Introduction of Brake Assist Systems to Regulation No. 13-H

The text proposed below modifies ECE Regulation No. 13-H to introduce specifications for Brake Assist Systems where fitted.

A. Proposed Amendments to ECE Regulation No. 13-H

Figure 1: Pedal force characteristic needed in order to achieve maximum deceleration with Category 'A' BAS

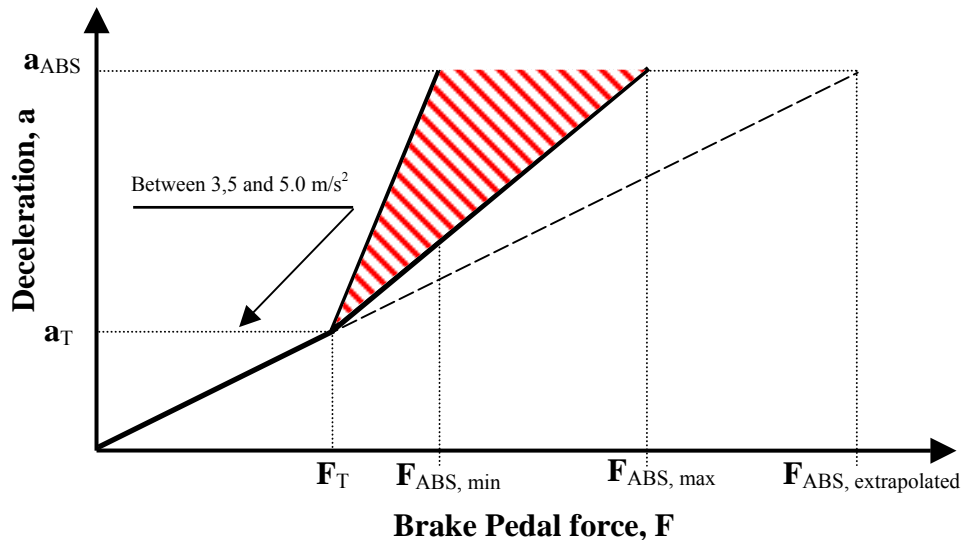
3.2.3 F_T and a_T are threshold force and threshold deceleration as shown in Figure 1. The values of F_T and a_T shall be supplied to the Technical Service at the time of submission of the type-approval application. The value of a_T shall be between $3.5m/s^2$ and $5.0m/s^2$.

3.2.4 A straight line is drawn from the origin through the point F_T, a_T (as shown in Figure 1). The value of brake pedal force ‘F’, at the point of intersection between this line and a horizontal line defined by $a=a_{ABS}$, is defined as $F_{ABS, extrapolated}$.

Figure 2: Test 2 of a Category 'B' BAS system.

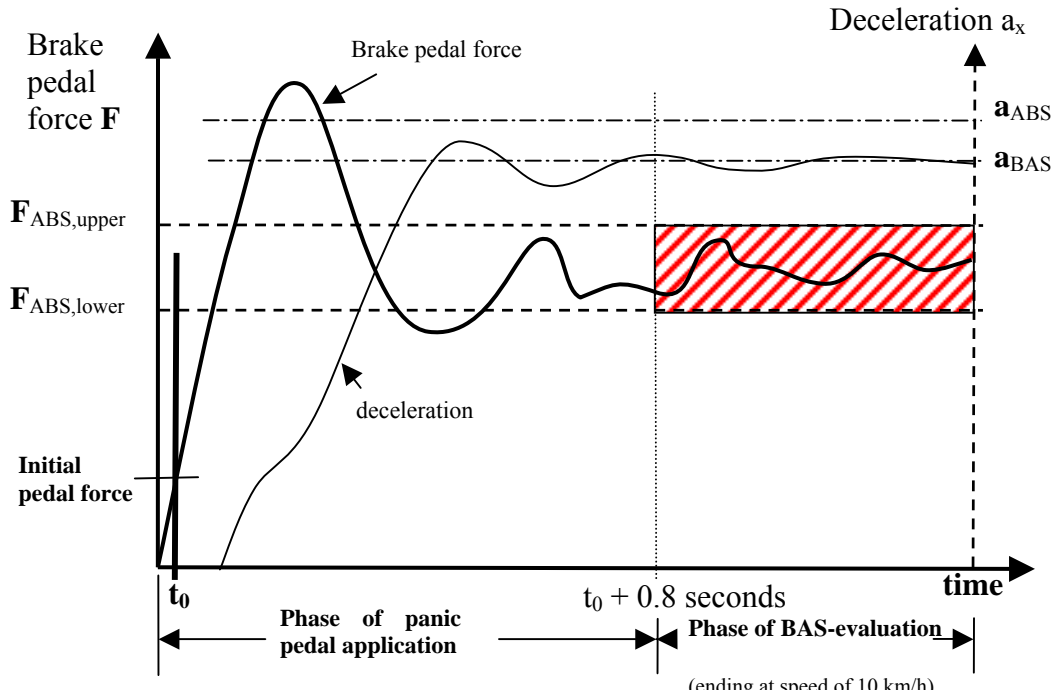
The vehicle shall be driven in a straight line at the test speed specified in 2.4 above. The driver shall apply the brake pedal quickly according to Figure 2, simulating emergency braking so that BAS is activated and ABS is fully cycling.

After $t = t_0 + 0.8$ s and until the vehicle has slowed down to a speed of 10 km/h the brake pedal force shall be maintained in a corridor between $F_{ABS, upper}$ and $F_{ABS, lower}$. Where $F_{ABS, upper}$ is $0.7 F_{ABS}$ and $F_{ABS, lower}$ is $0.5 F_{ABS}$.

Figure 3: Deceleration corridor for determination of F_{ABS} and a_{ABS}

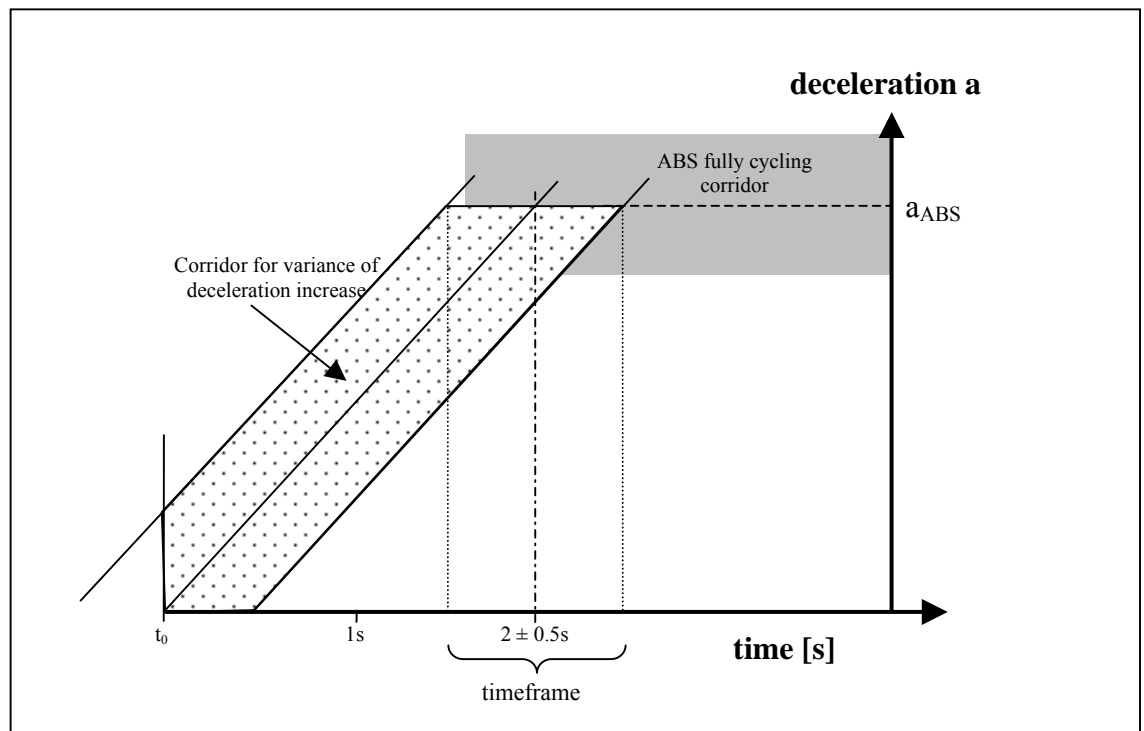
- 1.2 The brake pedal shall be applied slowly (without activating the Brake Assist System) providing a constant increase of deceleration until ABS is fully cycling (Figure 3). A brake pedal force of at least 600 N shall be achieved during the test.

- 1.3 The full deceleration must be reached within the timeframe of 2.0 ± 0.5 s. The deceleration curve, recorded against time, must be within a corridor of ± 0.5 s around the centre line of the deceleration curve corridor. The example in Figure 3 has its origin at the time t_0 crossing the a_{ABS} line at 2 seconds. Once full deceleration has been achieved the pedal travel [S_p] shall not be decreased for at least 1 s. The time of full activation of the ABS system is defined as the time when pedal force F_{ABS} is achieved. The measurement shall be within the corridor for variance of deceleration increase (see Figure 3).

Figure 4: Determination of the value of F_{ABS}

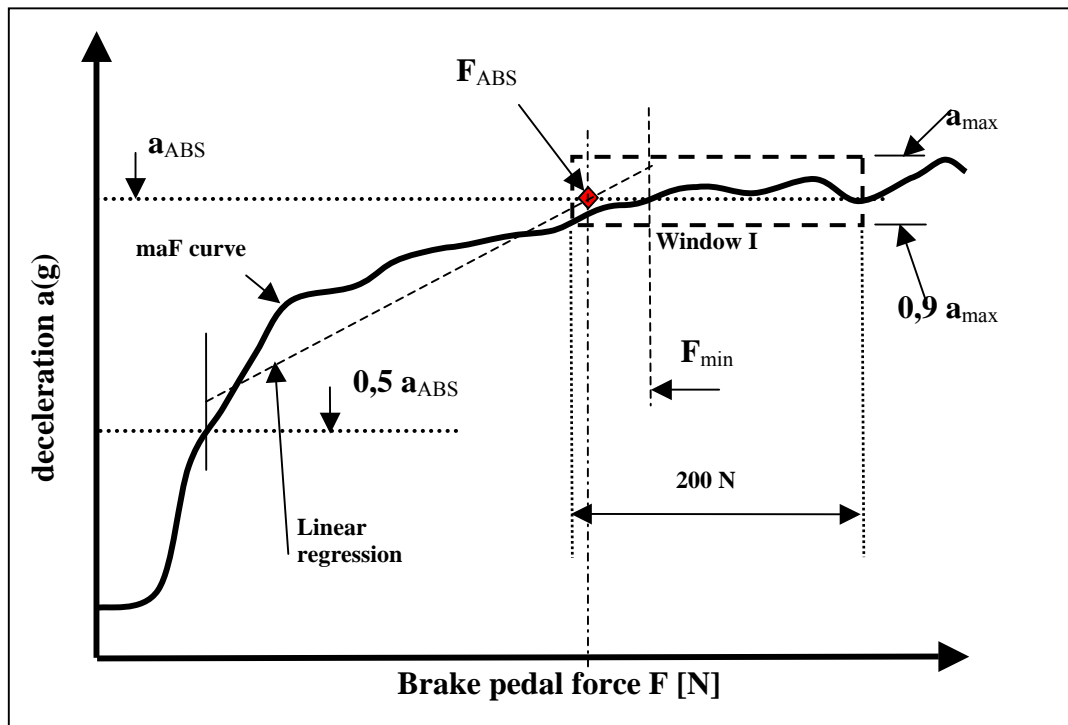
1.9 Using linear regression, a straight line is drawn through all maF curve values below the pedal force F_{min} and above the ABS deceleration value ($0.7 \cdot a_{ABS}$). The value of the brake pedal force ‘F’ at the point of intersection between this line and the horizontal line where $a = a_{ABS}$ is defined as F_{ABS} (diamond in figure 4).
